SERVICE UPDATE

SUBJECT: Service Update for Inventory and Customer Vehicles
Turbo-to-Exhaust Manifold Joint May Relax
Expires with Base Warranty

MODELS: 2013 Cadillac ATS
2013 Chevrolet Malibu
Equipped with 2.0L Engine (LTG)

3268362

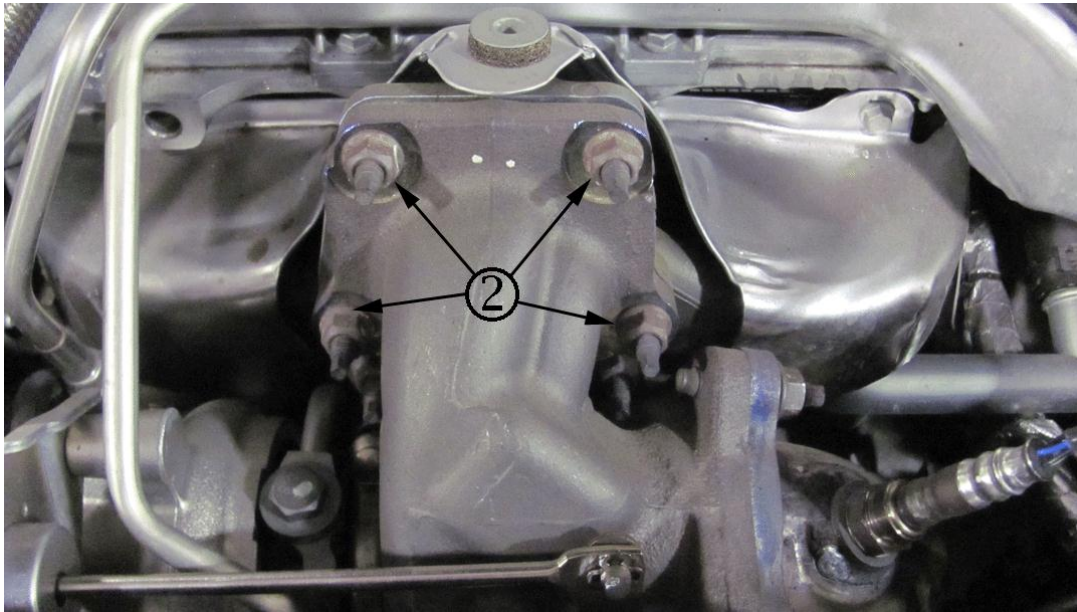
2. Locate the turbocharger exhaust heat shield (1).

3. Remove the turbocharger exhaust heat shield. Refer to *Exhaust Manifold Heat Shield Replacement (LTG)* in SI.
